Re: Proposed seniors housing development – 29-35 Lochinvar Road, Revesby

Re: Division 5.1 (Part 5) Activity (P5-2024-182) – 29-35 Lochinvar Road, Revesby Senior's Housing Proposal - Canterbury Bankstown City Council Advice

Canterbury Bankstown Council (Council) has reviewed the documentation submitted with this development proposal for the Seniors Housing Proposal at 29-35 Lochinvar Road, Revesby.

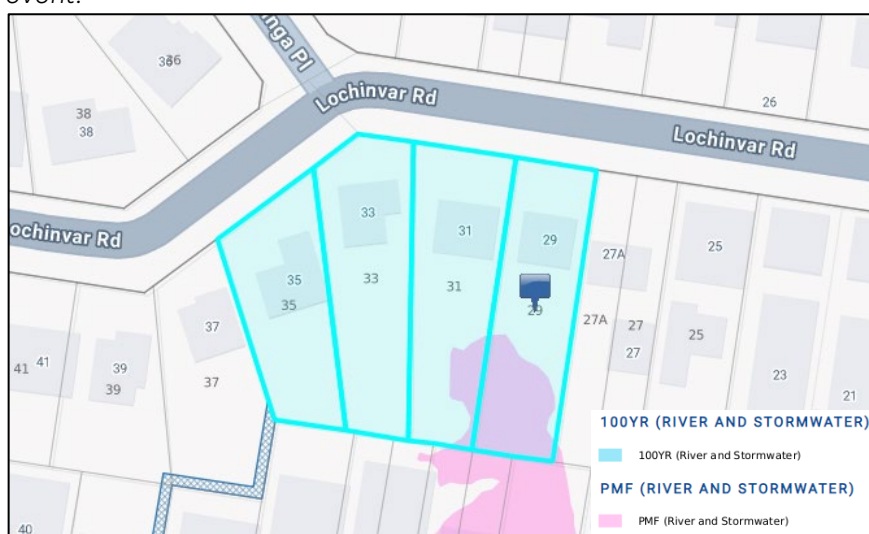
Council advises the certifier must not issue a Construction Certificate (CC) unless provided with detailed plans (included in the CC) for the bulky waste storage room that comply with the following requirements:

- a. To be a caged or well separated space within the waste room
- b. To be designed to a minimum size of 4 square metres (m²)
- c. Any doorways must be 2m wide and open outwards

Traffic, Vehicular Access & Footpaths

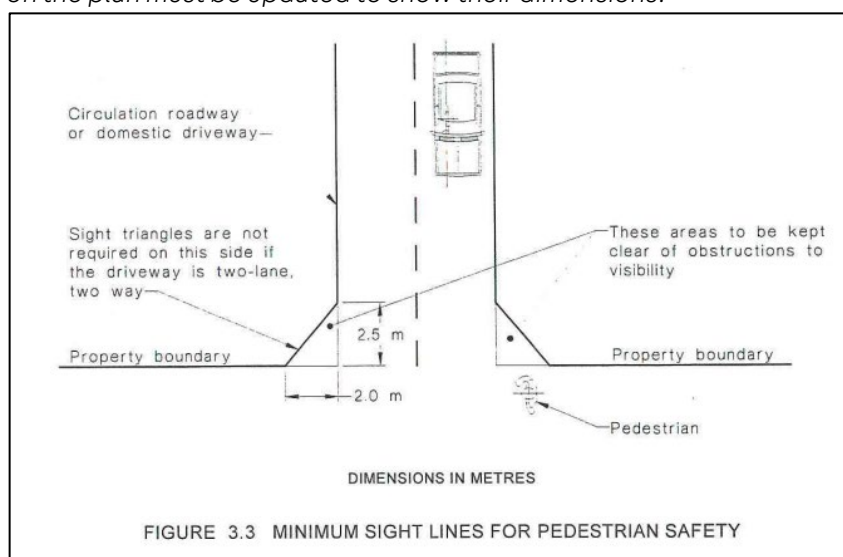
- Council notes the driveway width is stated to 3m in the Traffic and Parking Impact Assessment (TPIA) prepared by ParkTransit Australia Pty Ltd dated 11 October 2024. This may be an error and is to be corrected, as the plans show two vehicles being able to pass each other and this cannot occur with a width of 3m.

- Council advises the waiting bay and/or stop line is to be shown on the Architectural Plans prepared by DTA Architects.
- Council advises the proposed access driveway on Wenke Crescent must comply with Council's [Vehicular Footway Crossing \(VFC\) Policy](#) and Council's [Standard Drawings](#) as per 'S-004 Standard Location for VFCs and Property Drainage', in particular:

- Council advises that a splay extending 2m from the driveway edge along the front boundary, and 2.5m from the boundary along the driveway shall be provided to give clear sight lines of pedestrians from vehicles exiting the site and should be kept clear of any permanent obstacles. This is in accordance with 'Figure 3.3 - Minimum sight lines for pedestrian safety' (below) in Australian Standards AS2890.1:2004. The sight triangles shown on the plan must be updated to show their dimensions.
